<b>Company</b>	Trenz Electronic GmbH
<b>PCN Number</b>	PCN-20210621
<b>Title</b>	TEB0911-04 eMMC Change and Product Update
<b>Subject</b>	BOM change
<b>Issue Date</b>	2021-10-12

This change affects all Trenz Electronic TEB0911 boards of revision 04: TEB0911-04

## 2.7 #7 Set S/N to not fitted

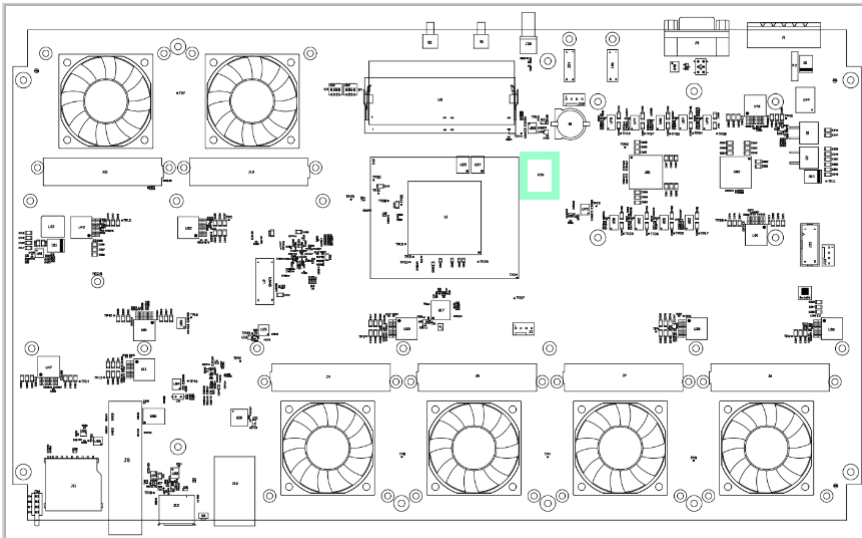
**Type:** BOM change

**Reason:** Part is end of life.

**Impact:** Track it pad no more available.
